Design Review Committee Meeting

Villages at White Oak 1st Addition Planned Development, Phase 1 Site Plan Review for Common Open Space Improvements

DATE: August 9, 2016

SUBJECT: Common Open Space Site Plan Review

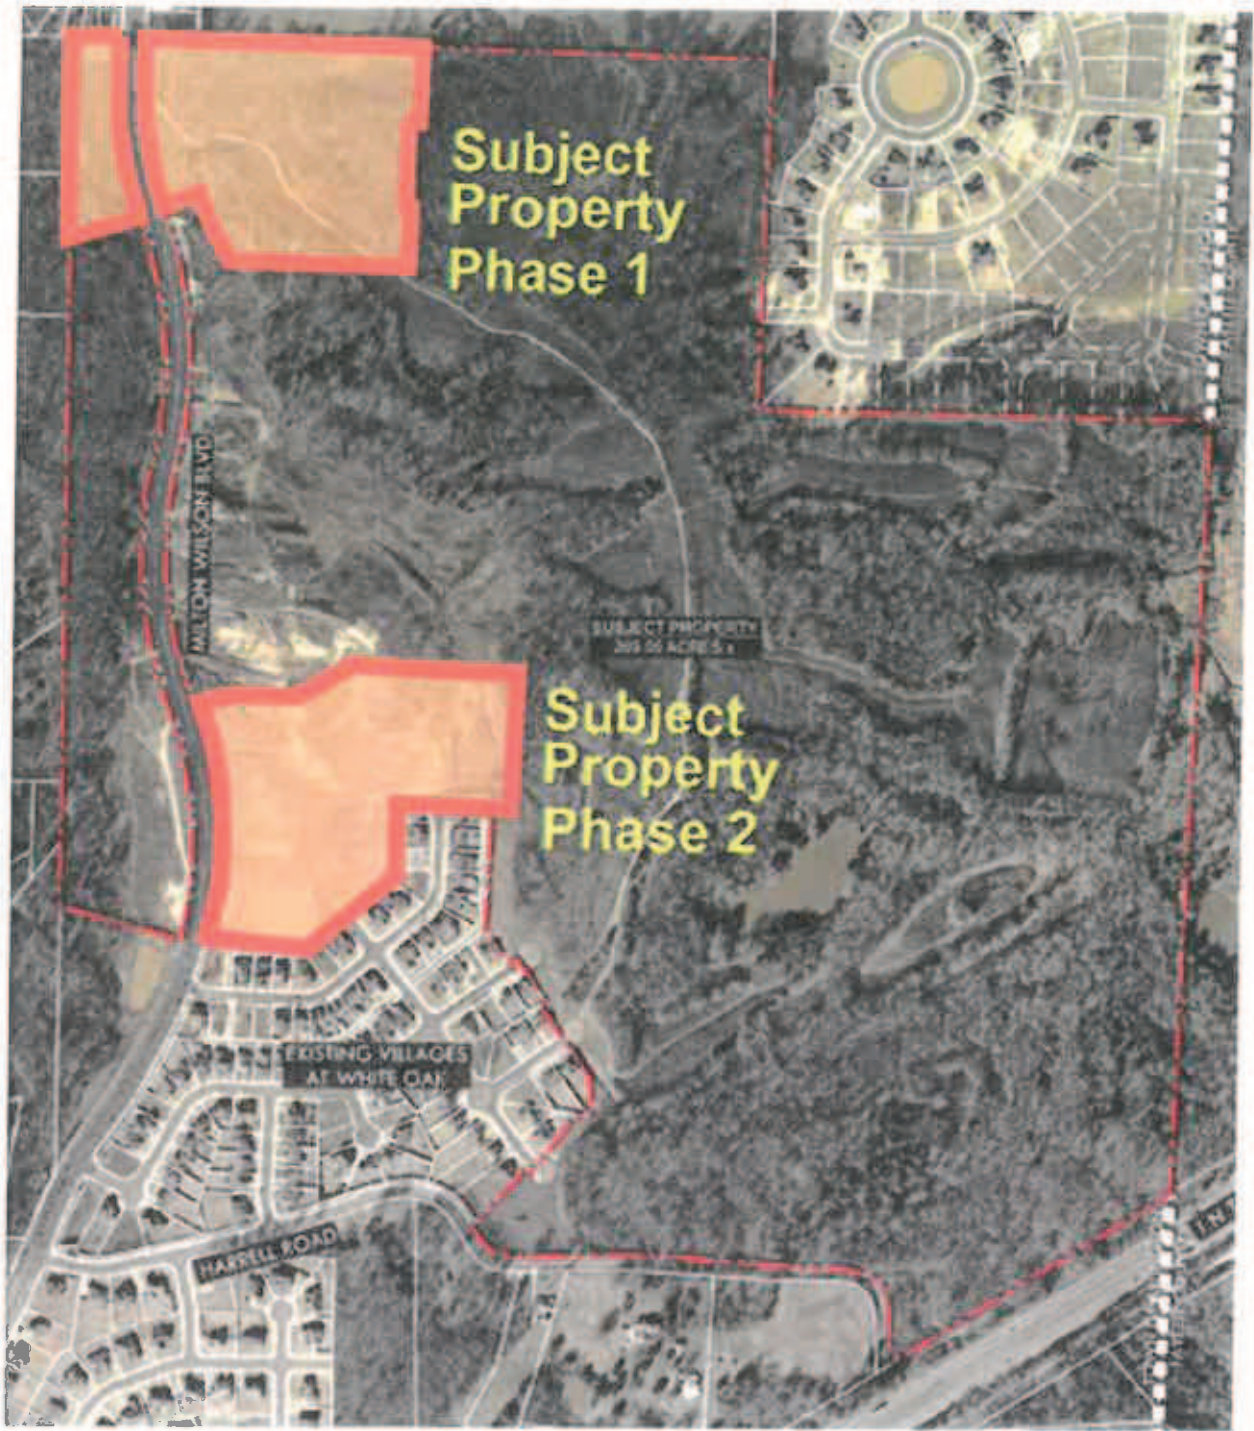
The applicant intends to request an alternate type of street lighting for this project, which as public infrastructure falls under the authority of the Planning Commission through the Subdivision Regulations. However, the applicant has provided a detail of the lighting they propose and the DRC may provide an advisory opinion on the proposed lighting design, should they wish. The lighting is a decorative, black light fixture proposed on an 8ft tall, round, decorative pole.
